**STATEMENT OF HILL FARMS NEIGHBORHOOD ASSOCIATION  
PLANNING COMMITTEE CONCERNING WISCONSIN DEPARTMENT  
OF ADMINISTRATION HILL FARMS STATE OFFICE BUILDING SITE  
GDP PROPOSAL**

**July 19, 2007**

# REDEVELOPMENT DISTRICT PLAN

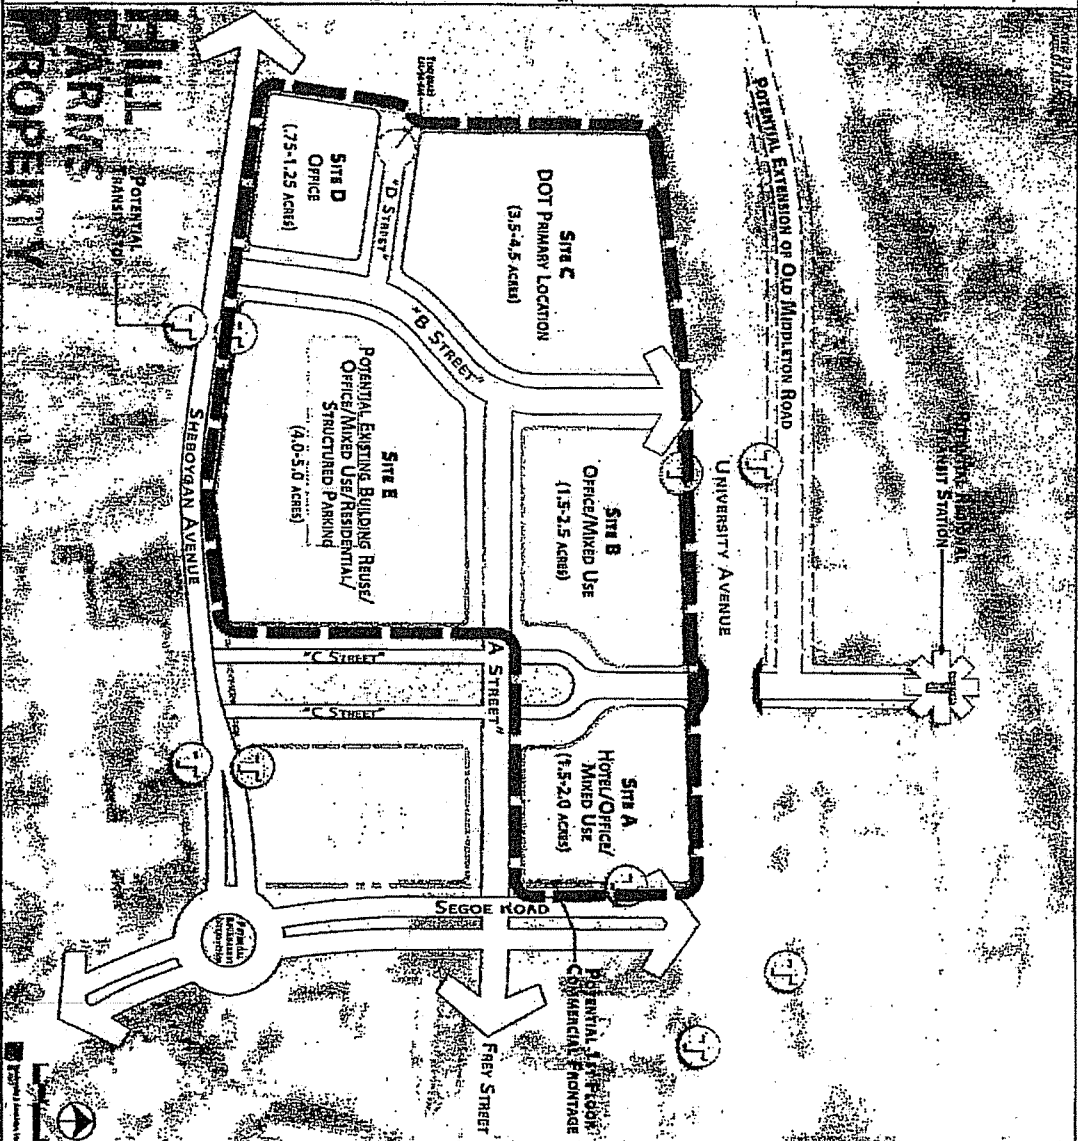
I. The GDP should provide that the height of buildings on the site shall be reviewed on a case-by-case basis in each SIP, but that proposed buildings in zones B and C which are proposed to be 15-20 stories shall be approved only if exceptional building design, the provision of substantial public or private open space, sustainable design characteristics, or other circumstances justify such height.

Q. The GDP should state that the minimum setbacks along Sheboygan Avenue will be 25 feet, and along Segoe Road 15 feet, but these minimums may be reduced by up to 5 feet at the time of SIP approval if the SIP proposes a plan which provides substantial public or private usable open space, green roofs, or other site or building designs which compensate for the narrower setbacks.
